Addendum 2

DATE	11/13/2026
PROJECT NAME	BL572 – Intercollegiate Athletics Gymnasium – First Floor HVAC & Lighting Upgrades
INTROBA PROJECT #	2035.0013084.001
IU PROJECT #	20250522
DISTRIBUTION	Owner
ADDENDUM CONSIST OF	(32) 8.5 x 11 PAGES & (53) 30 x 42 PAGES

DRAWING No.
ED-202

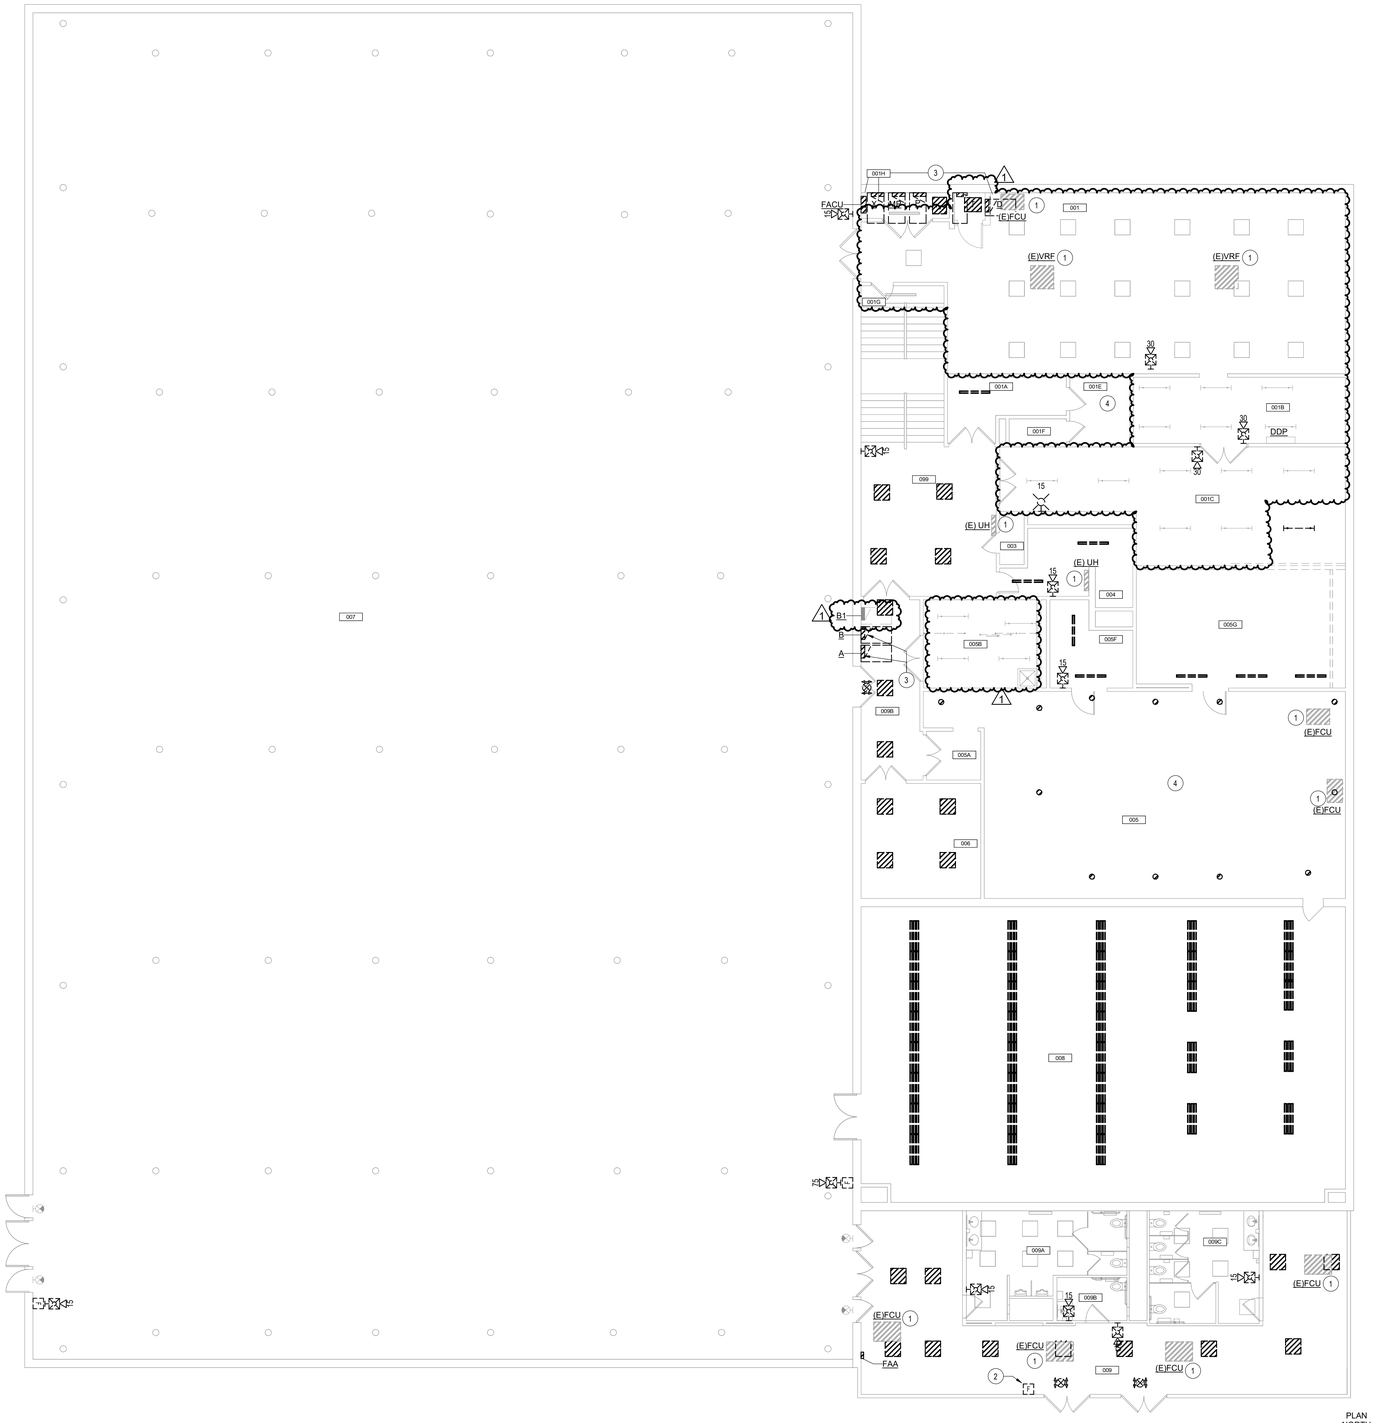
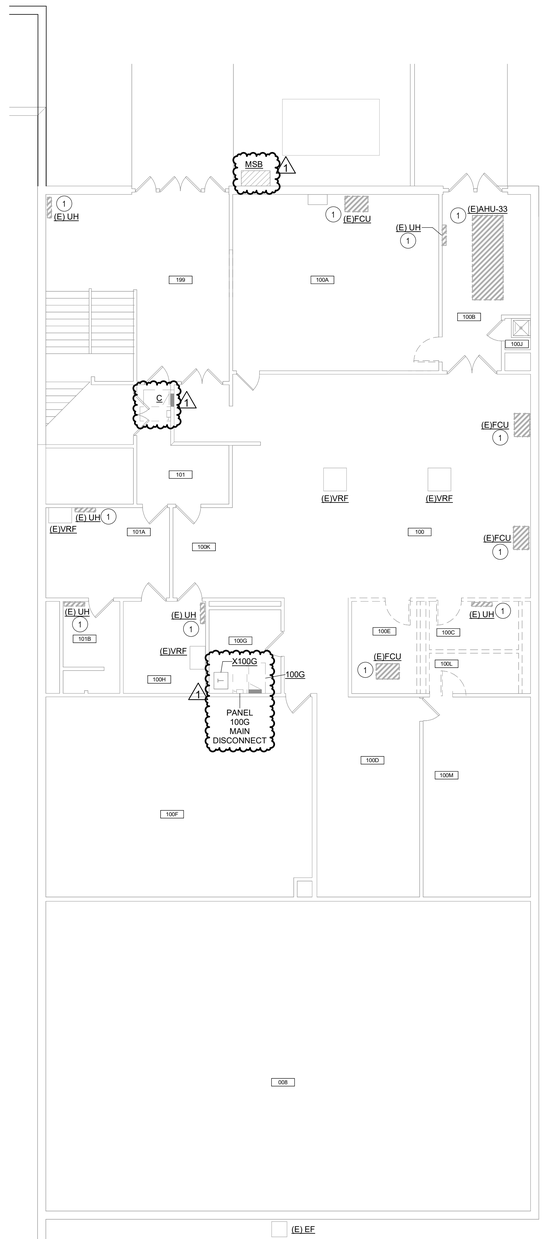
1. Modified graphical representation of existing panels, devices, and fixtures to clarify scope.
2. Modified sheet note three to add clarity to direction.

3. Added general note B to clarify fire alarm scope.

DRAWING TITLE
FIRE ALARM PLAN BL572 LEVEL 1

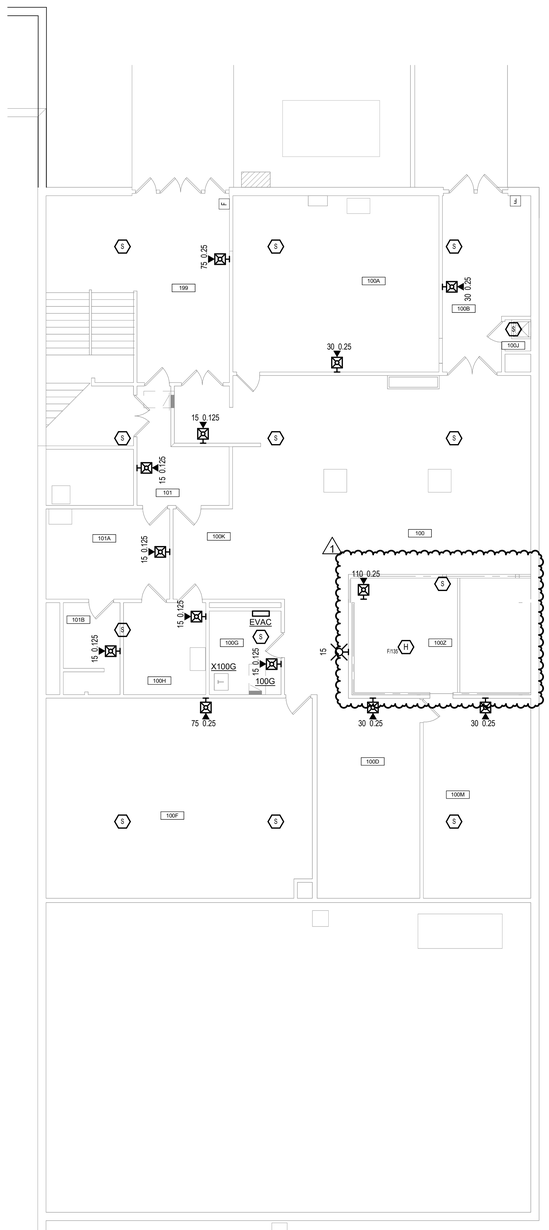
1. Added smoke detection to room 007.
2. Added visual device and smoke detector in room 009B.
3. Added smoke detector in transformer XD closet.

DRAWING TITLE
FIRE ALARM PLAN BL572 LEVEL 2

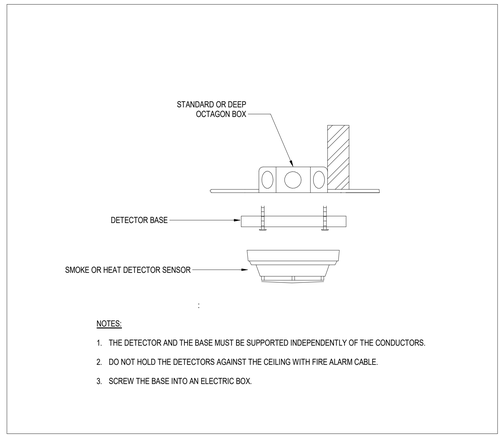
1. Modified fire alarm layout to align with architectural change of room 100Z

4 SPEAKER/STROBE CIRCUIT WIRING

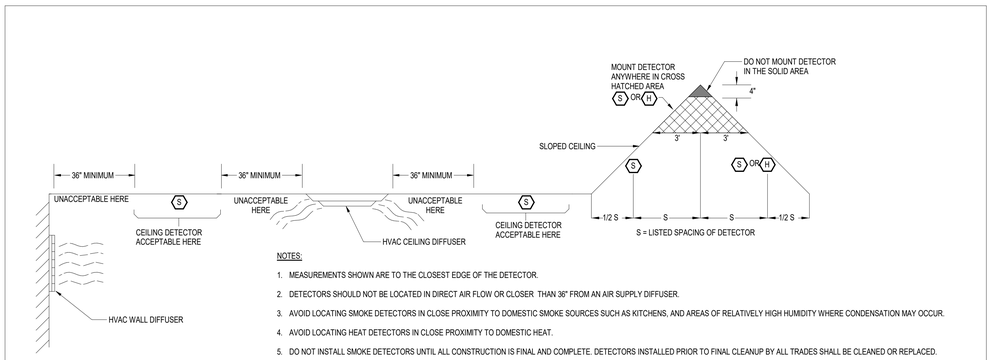
1. Modified notes on detail 4 to align to project parameters.
2. Modified fire alarm matrix to remove all mass notification for building.
